Subject: Engineering Report for the Surficial Cleanup and
Disposal of Chemical Wastes SCR&D Bluff Road Site
Columbia, South Carolina

ENGINEERING REPORT
for the
SURFICIAL CLEANUP AND DISPOSAL OF
CHEMICAL WASTES

SCR&D BLUFF ROAD SITE
COLUMBIA, SOUTH CAROLINA

SECTION 3: RESPONSE TO REQUEST FOR CHANGE ORDERS3.1 INTRODUCTION

FIGURE B-2
BLUFF ROAD SITE
Columbia, South Carolina
SITE AS BUILT

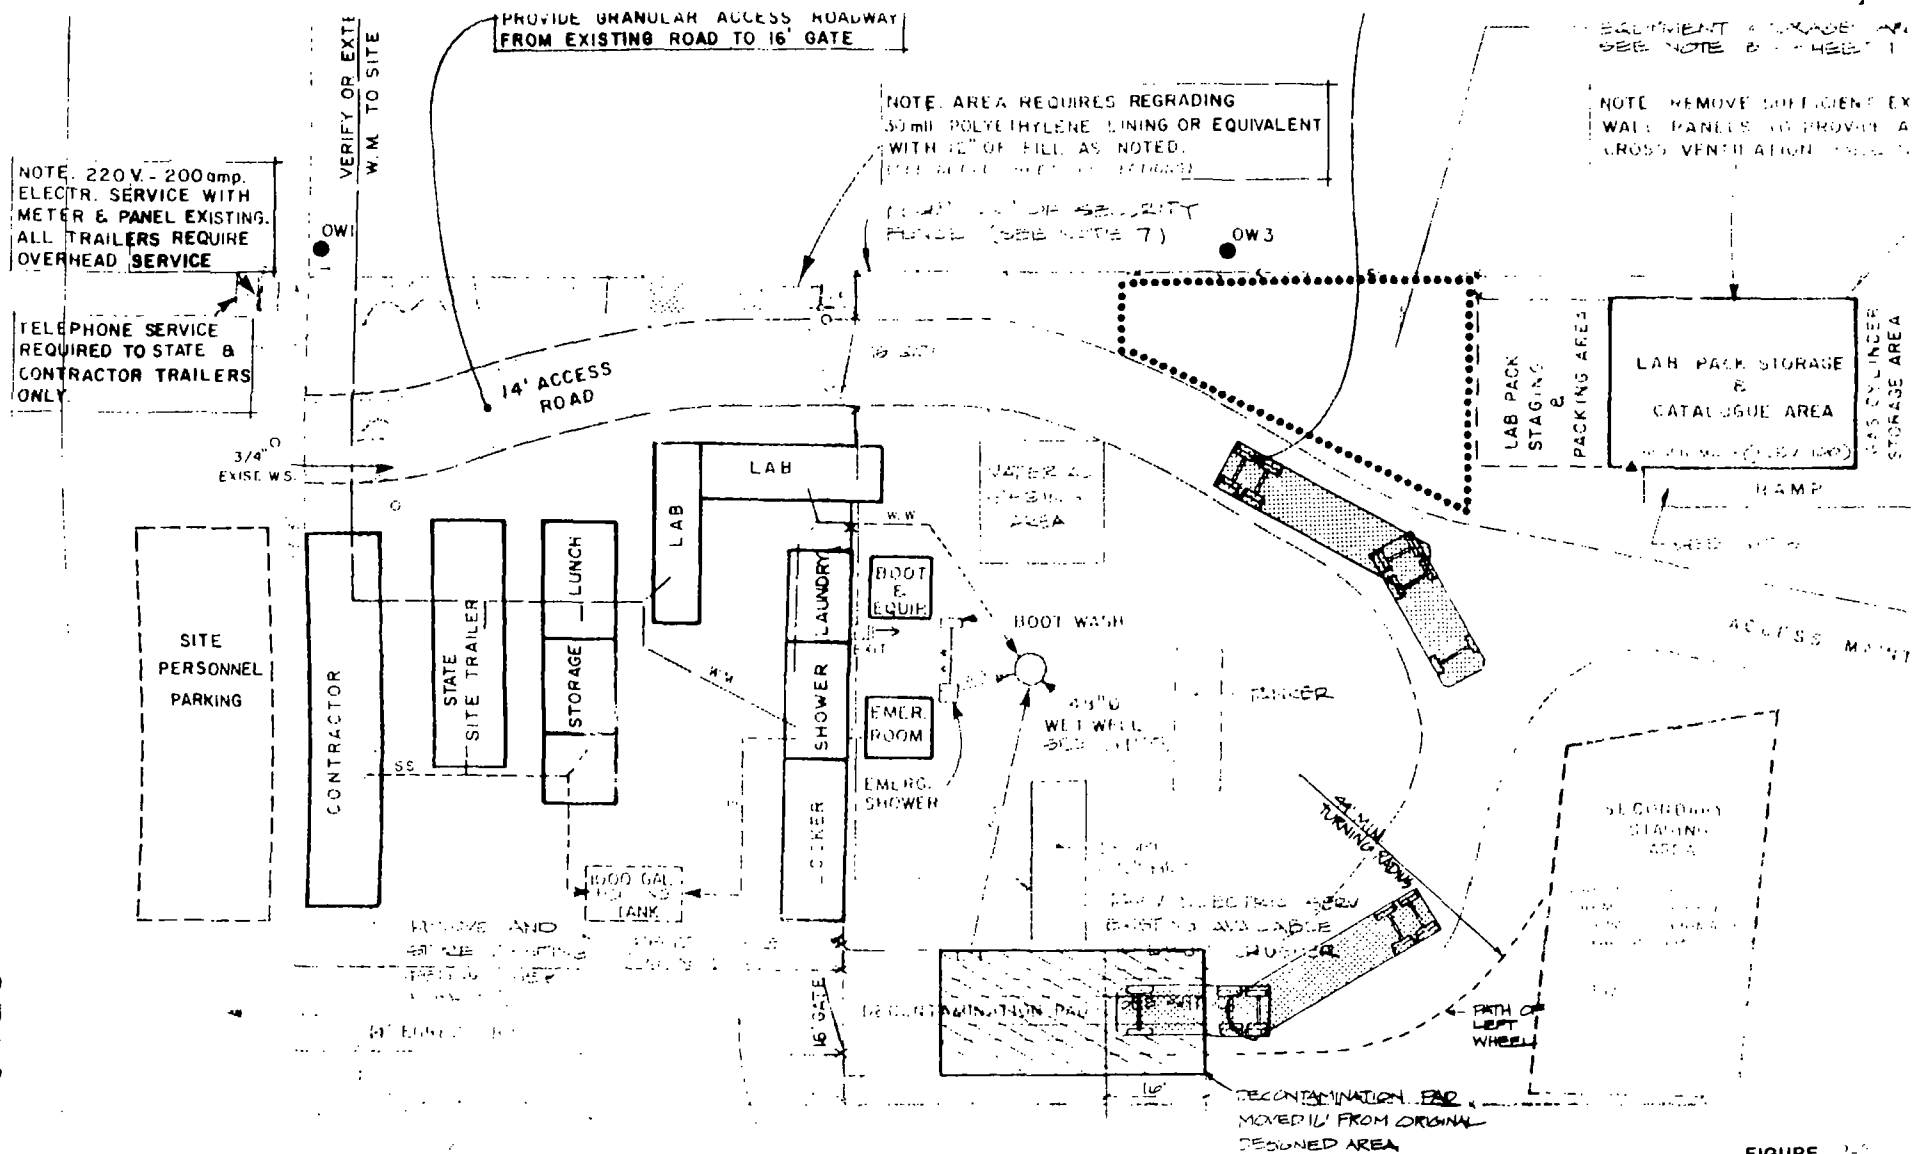
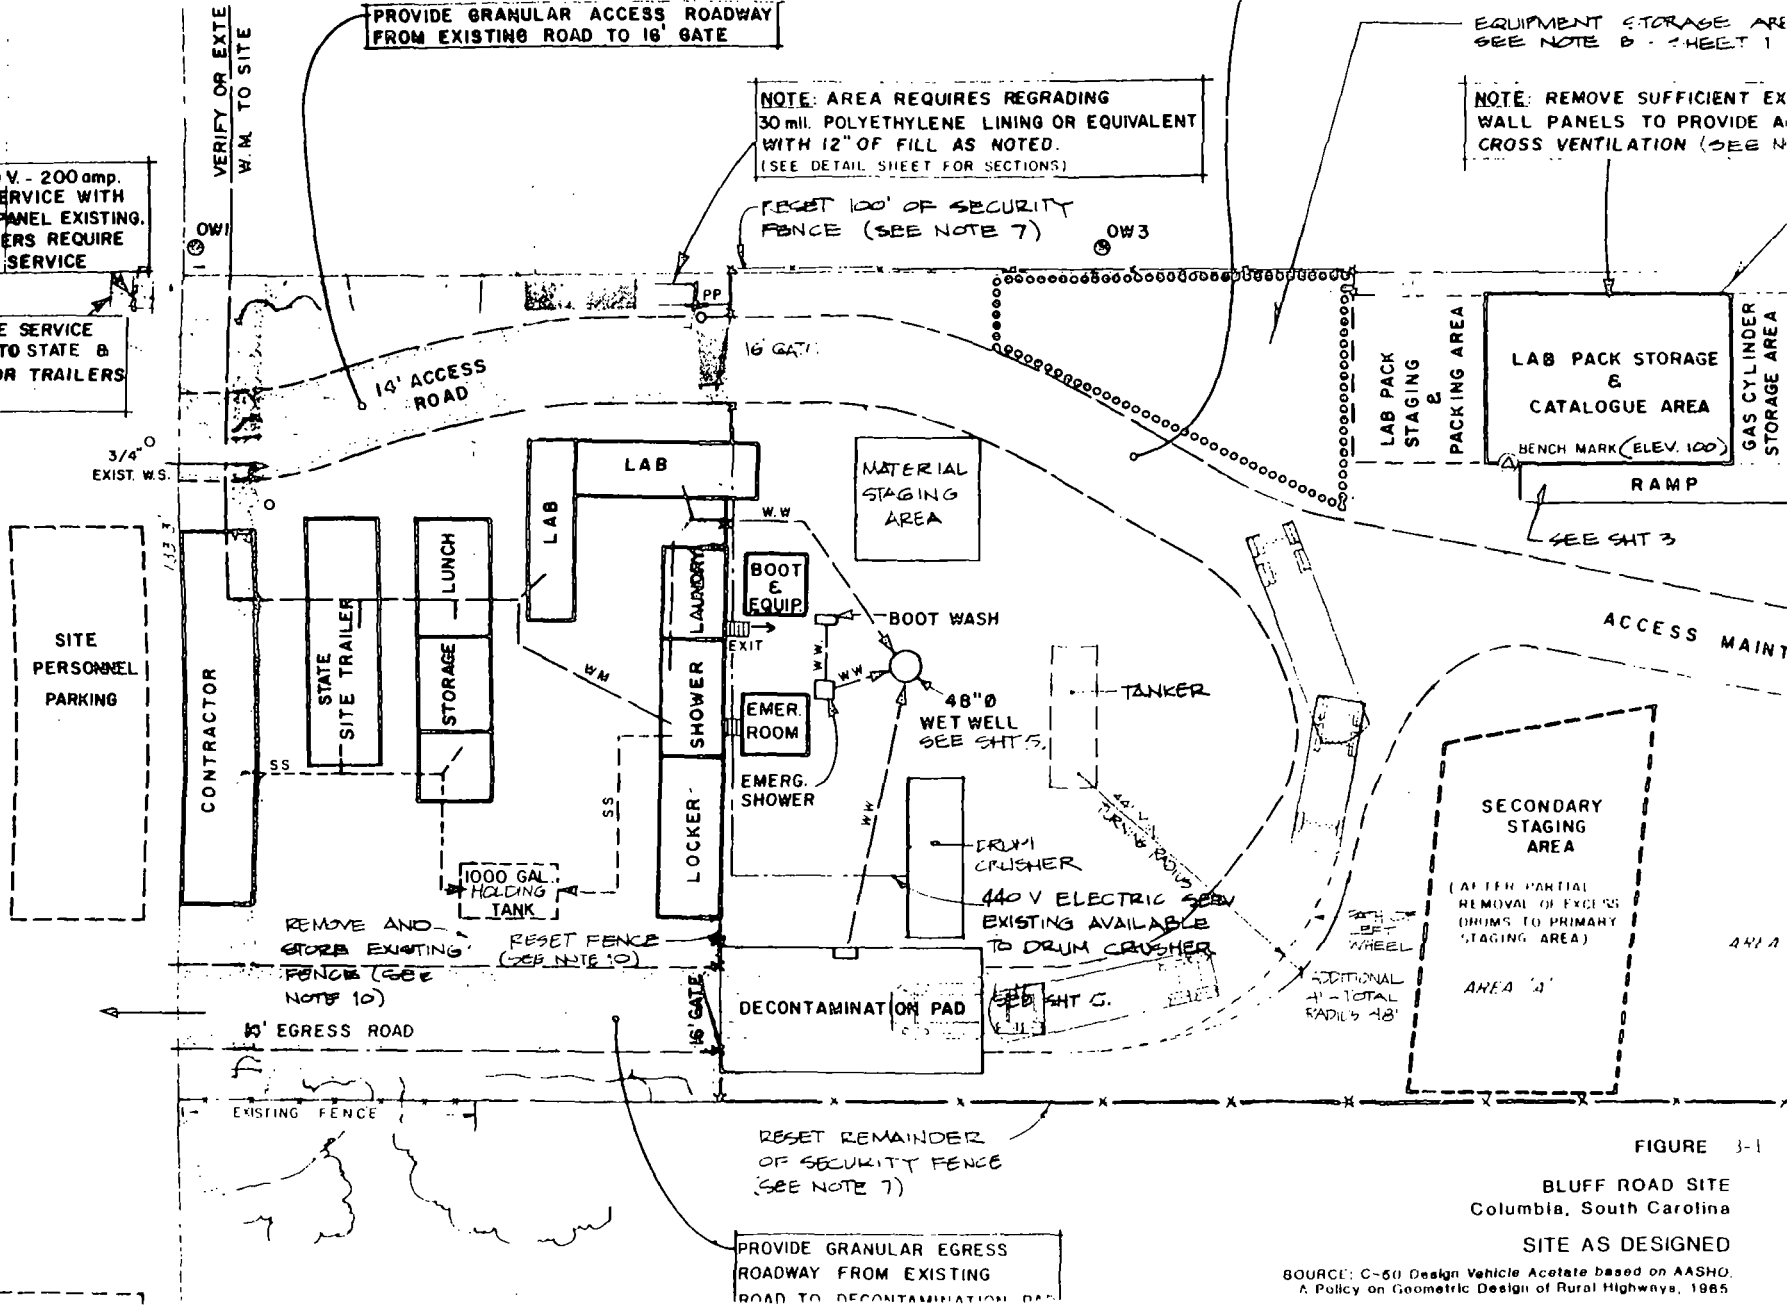
First, the contractor set both the clean/dirty zone fenceline and constructed the decontamination pad sixteen (16) feet too far into the site, reducing the critical dirty zone work area by over 2000 sq ft. This mistake impacted additionally on-site vehicle movement. Figure 3-1 illustrates the standard design turning radius for truck traffic, which requires a 44-foot turning radius. However, as shown on Figure 3-2, the placement of the decontamination pad sixteen (16) feet into the site changed the pivot point of the designed turning radius, making it impossible for a truck to make this turn efficiently. The attached photograph indicates the location of the front row of drums in Area "A" causing this turning restriction.

The contractor compounded the problem by not following the intent of the contract documents which specified these drums to be moved to the initial staging area. Figure 3-3 provides an inset from Drawing No. 3. As indicated, the building platforms were intended to be used as the initial staging area for the Area "A" drums. This would have provided for more working space in this critical front area. However, the contractor started moving drums from the middle of the site, filling this initial staging area and leaving Area "A" intact. This area remained filled with drums throughout the execution of the project.

CHANGE ORDER REQUEST NO. 15
ITEM E-4: Equipment Decontamination Facility with Wet
Well and Pumpage System

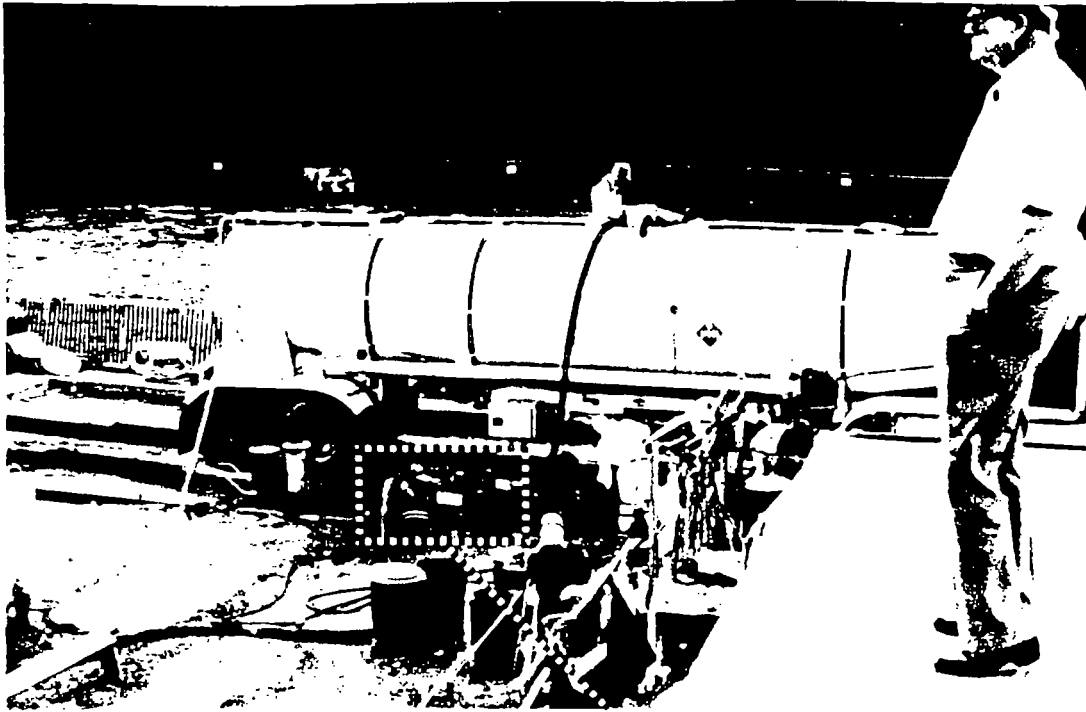
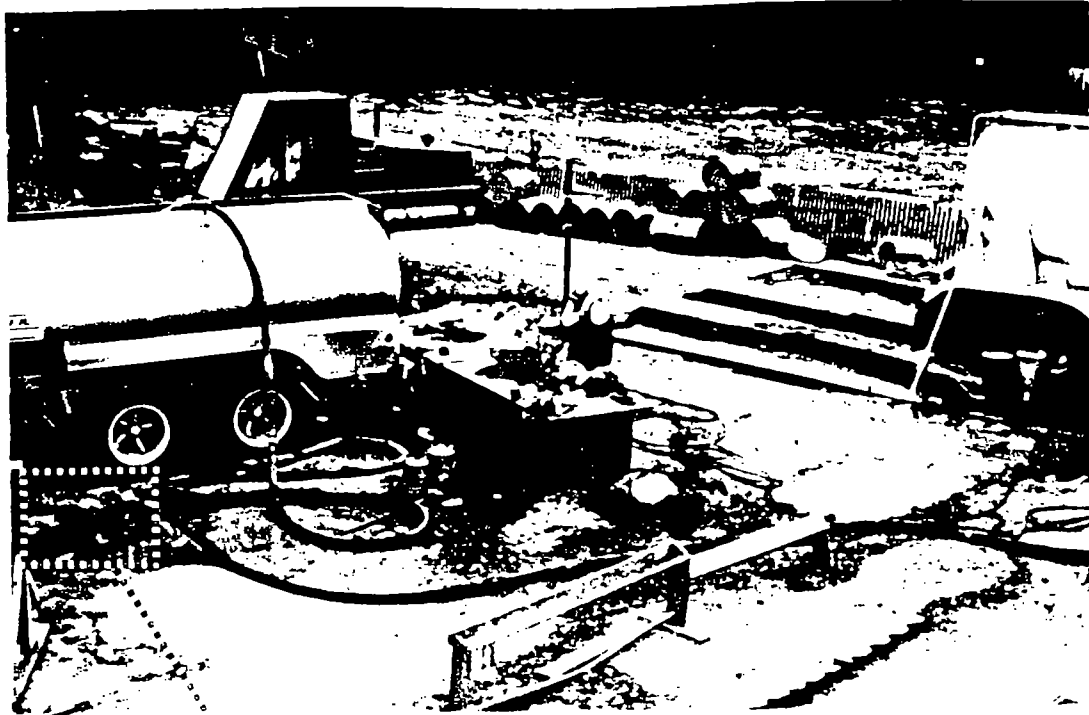
- o "This facility experienced almost three times as much activity as had originally been planned, generating 105,562 gallons of contaminated effluent instead of the 39,700 gallons as shown in the specifications. This required a great deal more maintenance on the facility including the pumps, steam and washing equipment, hoses and pressure guns."

Contract Documents specified that a pump would be installed in the Wet Well. Although the pump was installed, it was not used. The pump shown which was used contributed to the contractors space and site organization problems.

Response to Request - Item E-4 covers the construction of the Decontamination Facility as a lump sum item. The use of the facility for the decontamination of equipment was paid on a per gallon basis under Item F-20, which is the subject of Change Order Request No. 21. The payment for Item E-4 was based on:

If Defender incurred additional maintenance costs associated with extended operation of the decontamination facility and wet well including electrical service these should be submitted to the Owner for review.

Therefore, Defender should have included in this unit price the decontamination equipment and related maintenance. Additional costs associated with the extended decontamination required beyond that included in Defenders original unit bid price should be documented and submitted under Item F-20, which is discussed in Change Order Request No. 21

FIGURE 16-1: CHANGE ORDER NO. 16

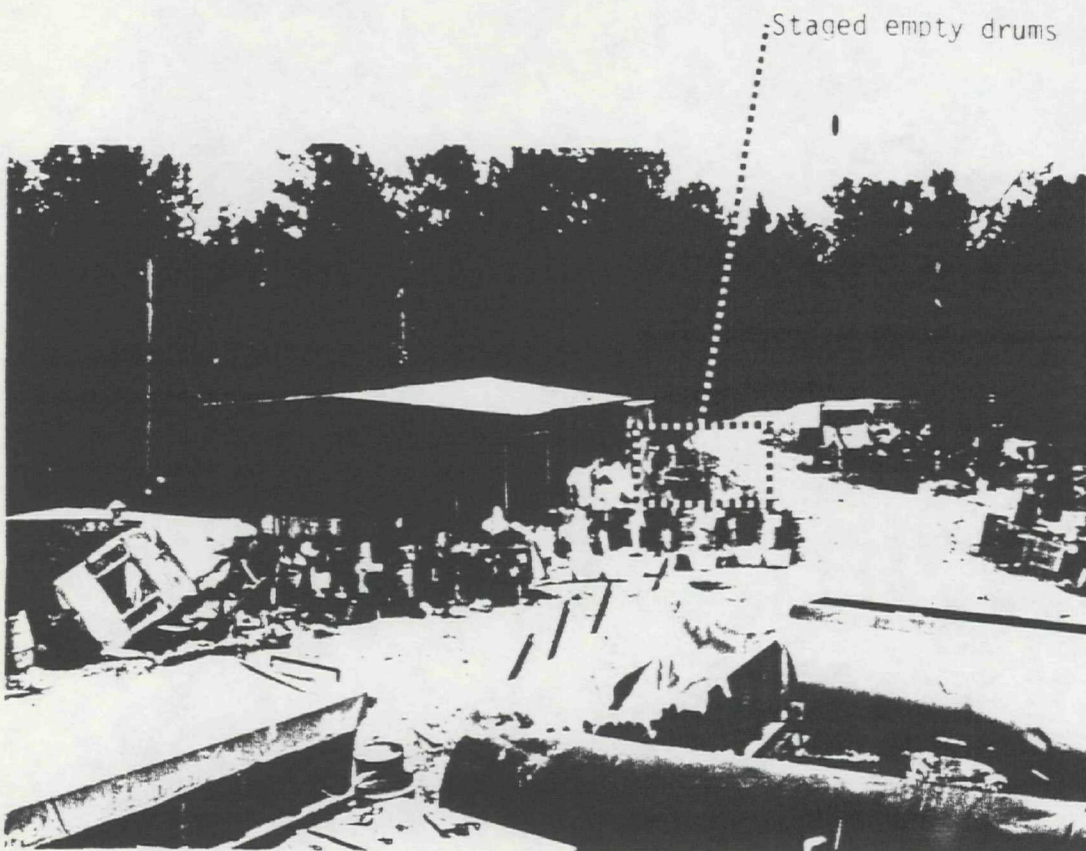
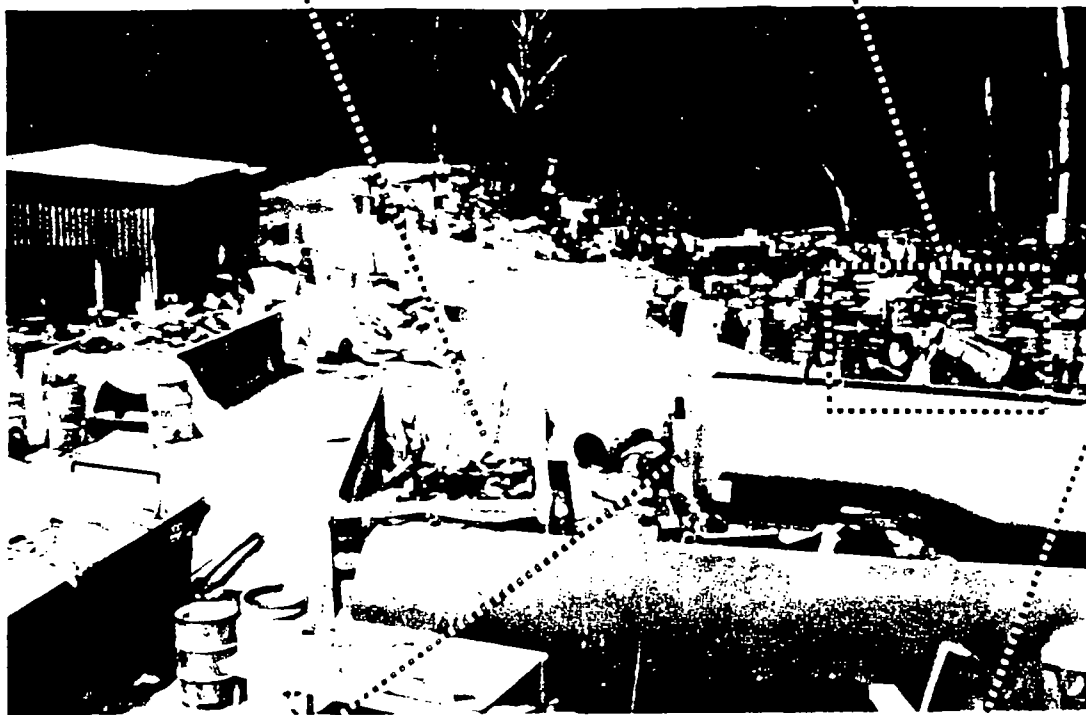
In response to the claim that, "only five to six drums could be placed near the crusher", the reader is directed to the attached photographs showing substantially more than six empty drums stored on site.

Response to Request - The delay in the drum crushing operation was not a matter of "congestion" but was due to Defender not having a drum crusher available on-site when required. Drum staging and sampling started April 26; the drum crusher was not delivered until May 9; and it was not until May 18 that the drum crusher was hooked up and operational. Once the drum crusher became operational, it is clear that the work proceeded adequately. The following lists the first week of drum crushing.
